## D.R. HORTON HEADQUARTERS SPMP

### SUMMARY

Updated Elevations, 12/14/17

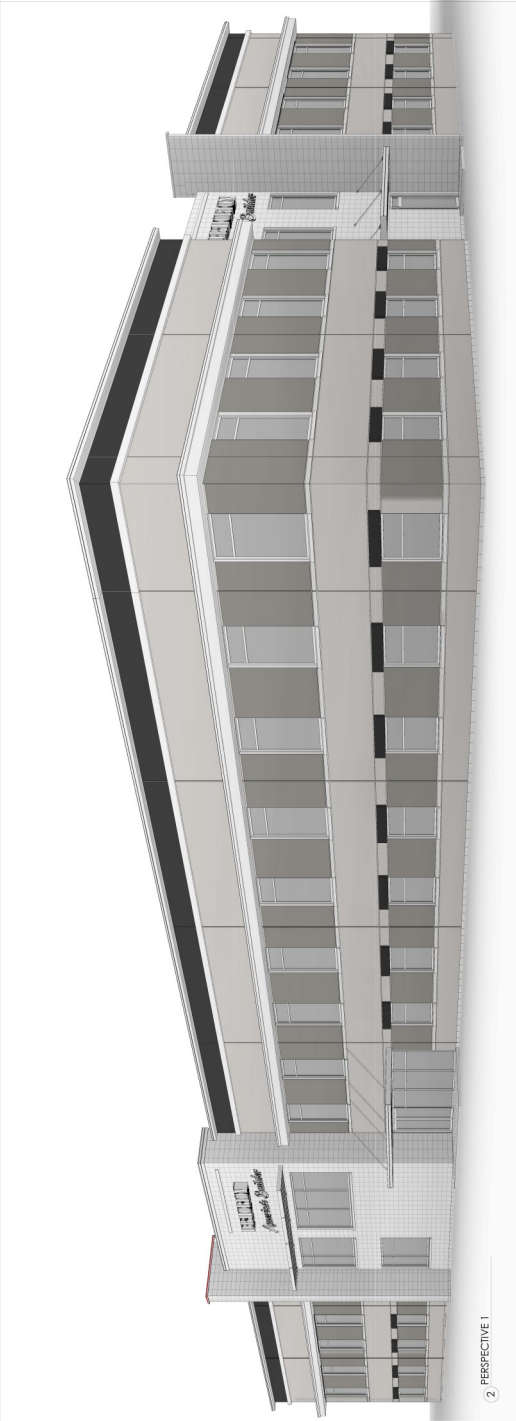
Building elevations and conceptual renderings are contained within this staff report, pages 16—21. Staff has concerns about the building elevations, which currently do not meet the conditions contained in the Urban Design section. Page 17 contains an exhibit displaying staff recommendations that are described in the Urban Design section which begins on page 25 of this report.

The building must be finished with durable, high quality materials that are authentic to the style of architecture for which the building is proposed. All facades shall be finished with the same materials and architectural details. Side and rear building façades that are visible from a public street shall contain architectural detail comparable in appearance and complexity to the front of the building. Durable materials such as stone, brick, or limestone shall be utilized at the base of the building.

- d. Consolidate the shade structures to have the appearance of spanning two windows vs. the one.
- e. A consistent cornice treatment detail must be applied around the entire perimeter of the building.

A single, dominant building mass should be avoided. The building elevations must be amended to provide substan-

tial variations in massing which should include changes in height and horizontal plane.
